IMPROVEMENT ON PRODUCTS	<b>CO01400, CO01410, CO01420 CO2100, CO2110, CO2200</b>
PART NUMBER	<b>RG00453</b>

PART NUMBER*	<b>RG00453</b>
IN PRODUCTION FROM	<b>July 2014</b>

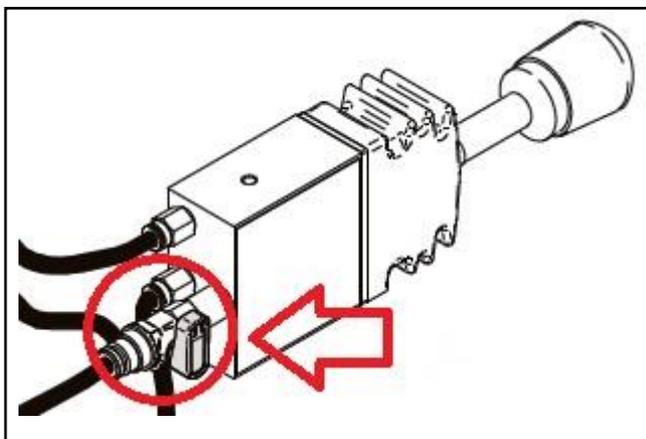
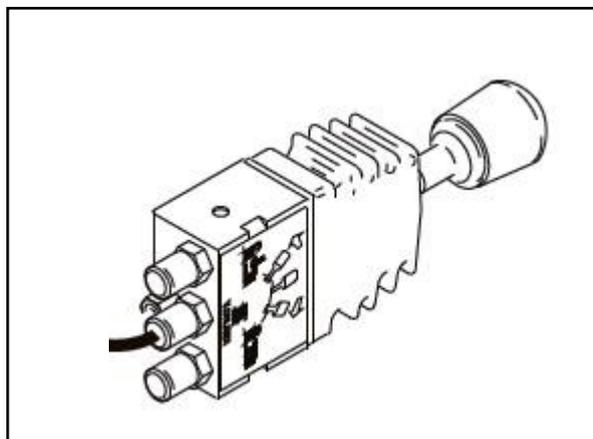
The above valve kit RG00453 has been now upgraded:

1. It can be retrofitted to any pneumatic V. ORLANDI complementary kit such as the ones listed above;
2. It includes an extra safety valve (underlined in red) to increase the safety; it allows the operator to cut the main air supply when driving;
3. The operator after checking that the coupling is properly closed, must then turn the valve in "OFF position" when driving.
